# Access Compliance Report Public Rights-of-Way (Curb Ramps)

Main Street: THORNHILL\_ST Cross Street: WYNDHAM\_ST Location: E

ADA ID: RPRK211028160828 Ramp Type: Type 4 - Parallel Initial Pass/Fail: Fail Overall Compliance: No Severity Score: 32

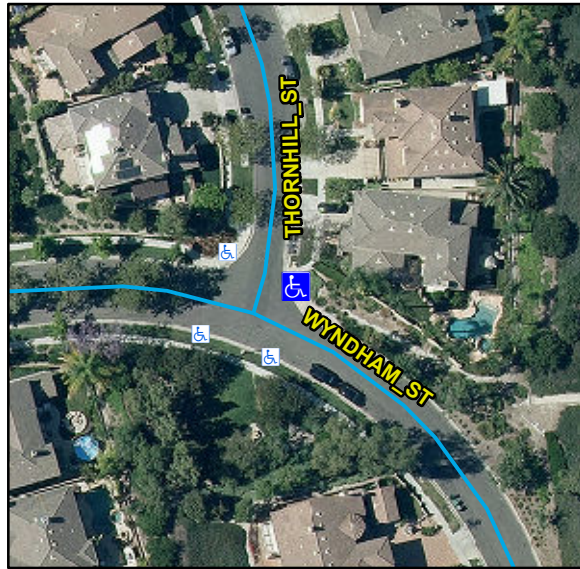
| Compliance | Description                   | Data       | Compliance | Description                   | Data |
|------------|-------------------------------|------------|------------|-------------------------------|------|
| Yes        | Ramp Run Slope LT (%)         | 3.9        | No         | Ramp Run Slope RT (%)         | 19.5 |
| No         | Ramp Cross Slope LT (%)       | 3          | No         | Ramp Cross Slope RT (%)       | 4.4  |

Remove & Replace Curb Ramp With Two New Directional Ramps or Equivalent.

R204.3, R304.5.3, R304.3.2, STD 1115
